PCN – Process Change Notification

Change:	OMB.868.B05F21
Date:	2017/02/23
Author	Bonnie Chen

Model#	Part Number	Changes
868MHz 5dBi Omni Antenna, with N Type Female Connector, U-Bolt, 818.75mm Length	OMB.868.B05F21	<ol style="list-style-type: none"> 1. Change Antenna Length 2. Amend Details on Drawing 3. Amend Package Rule

Illustration of Change

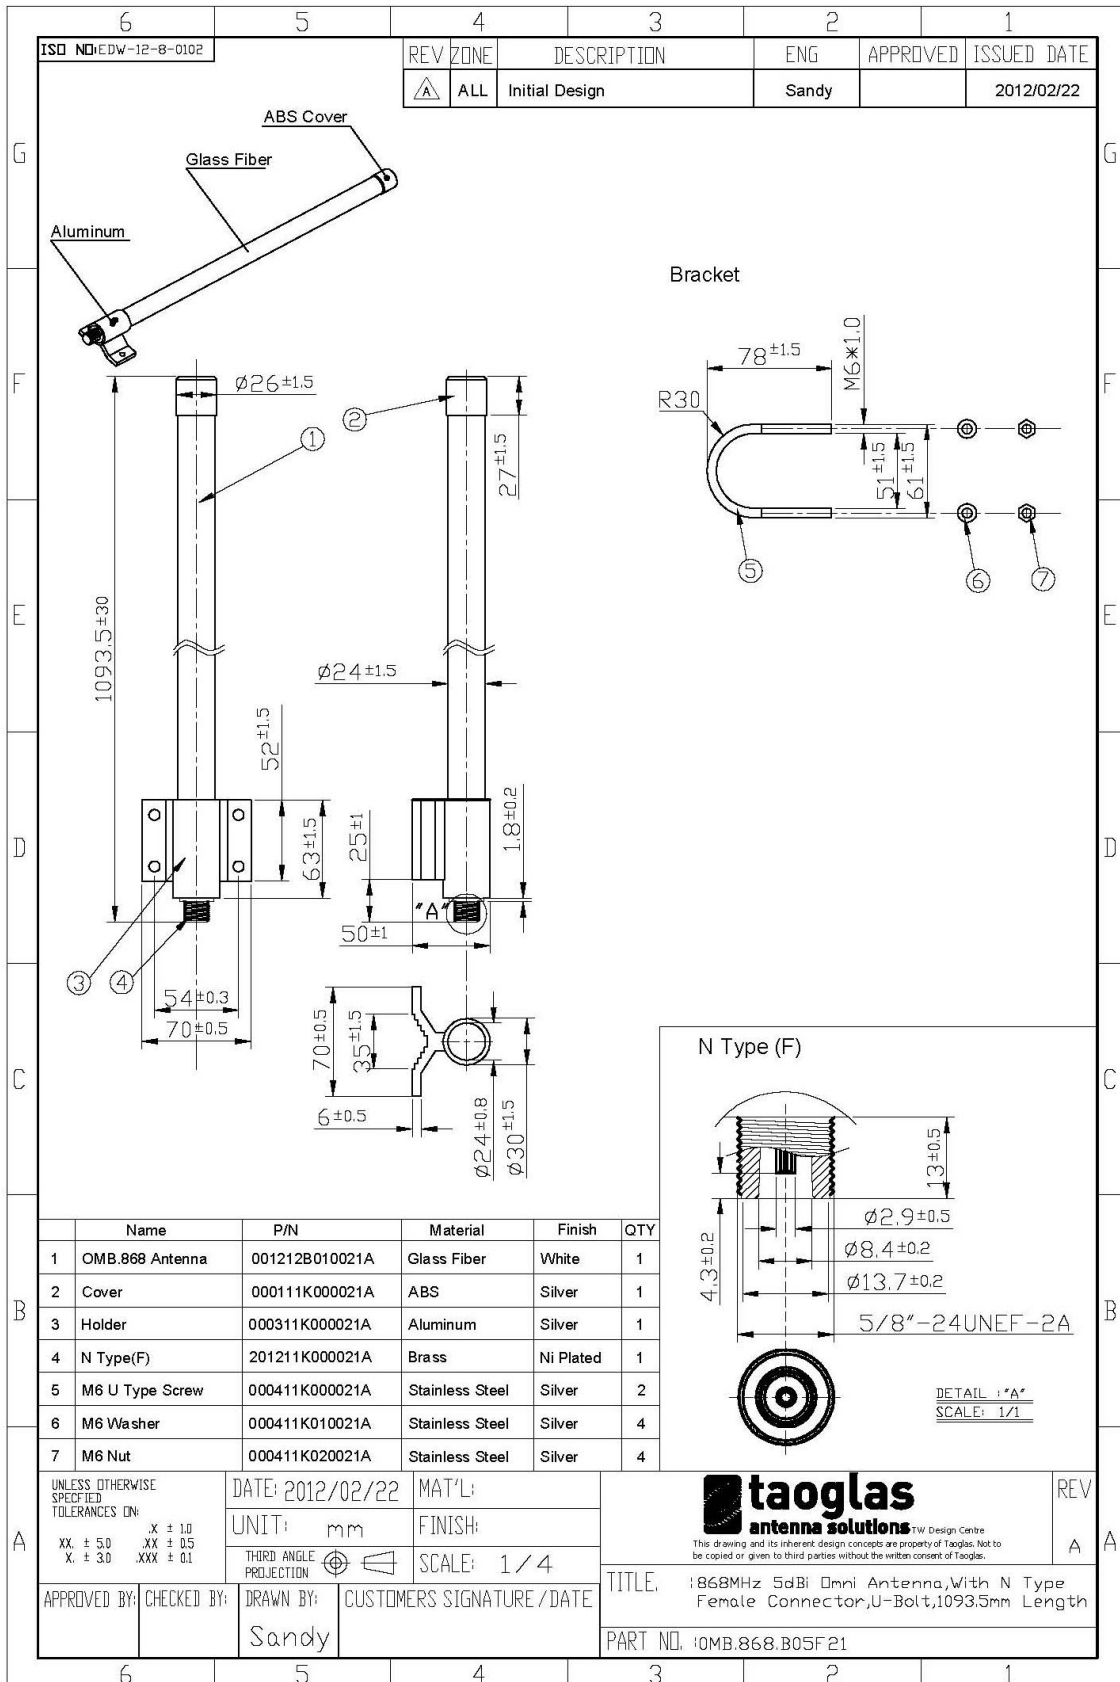
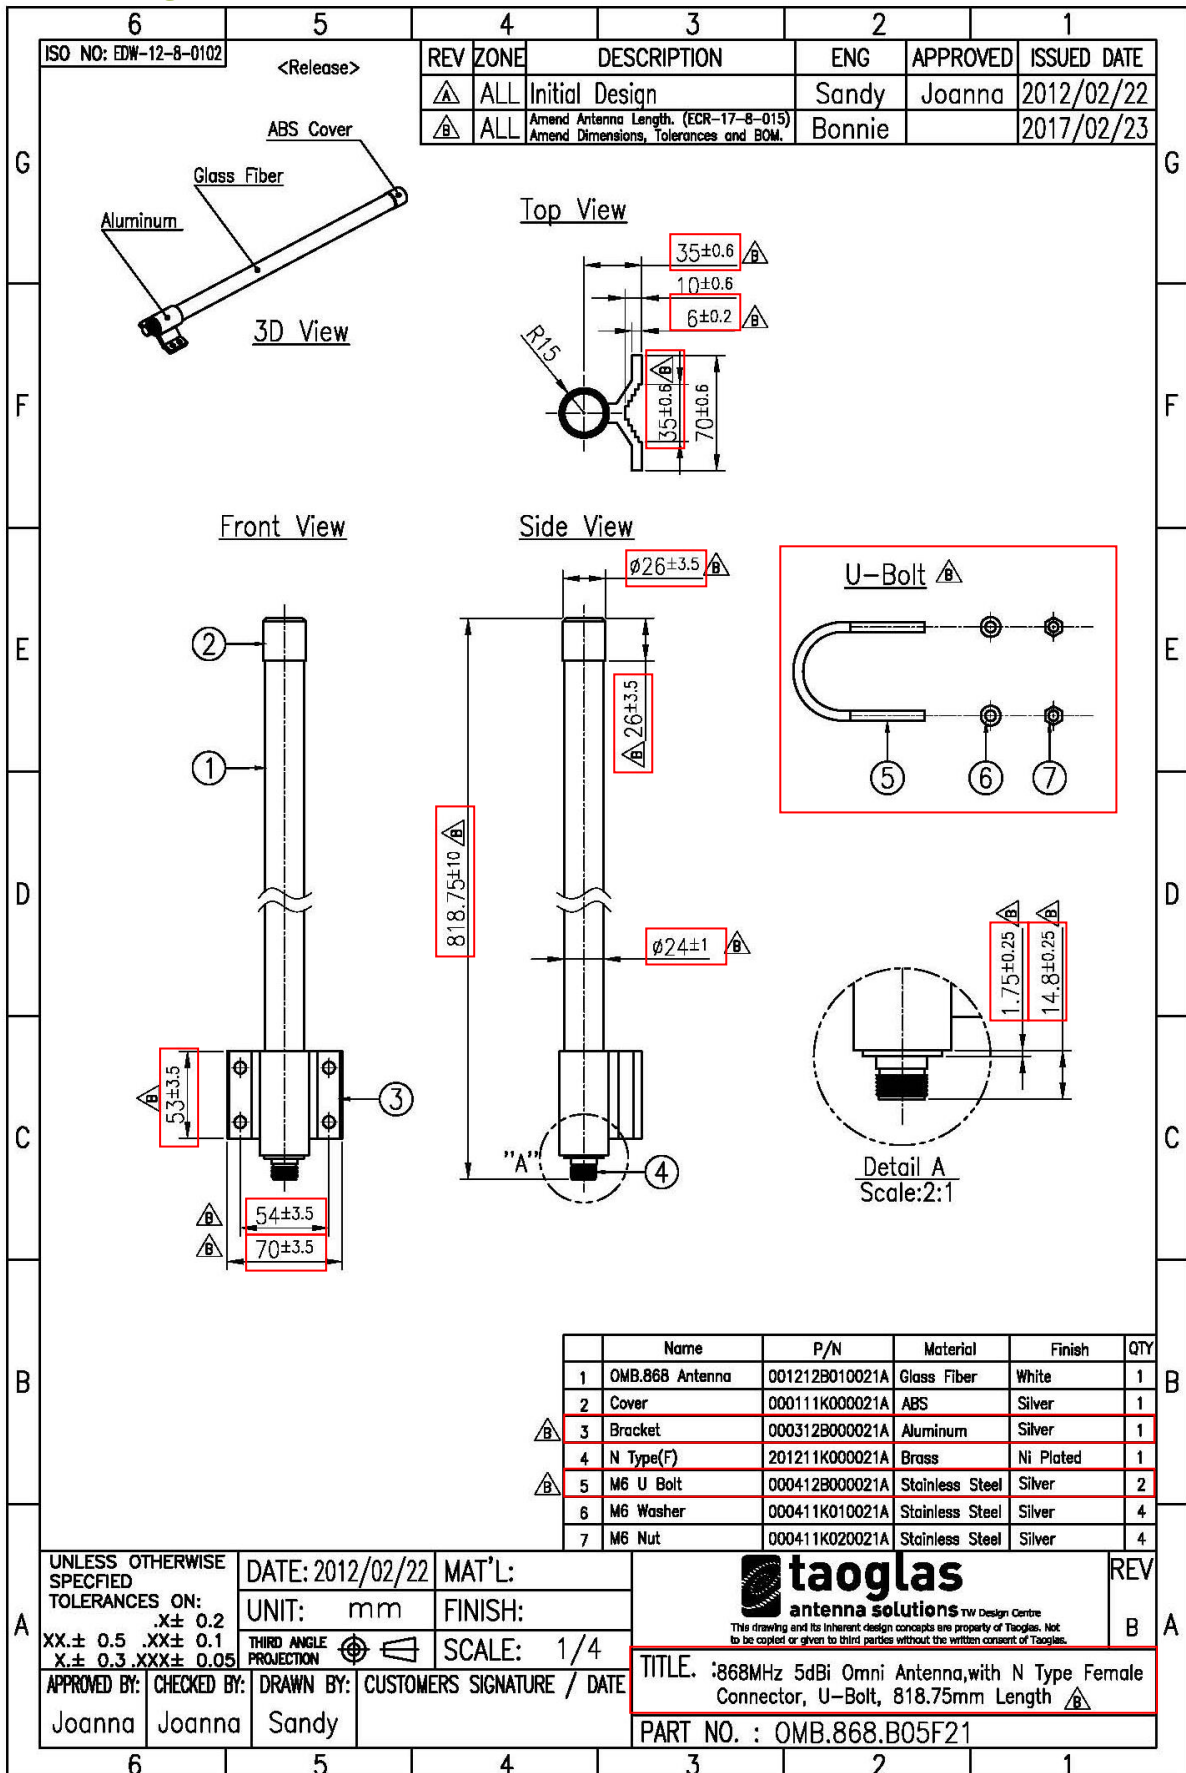
1. Amend Antenna Length from 1093.5+/-30mm to 818.75+/-10mm.
2. Amend Title, Dimensions, Tolerances and BOM on Drawing.
3. Amend Package Rule.
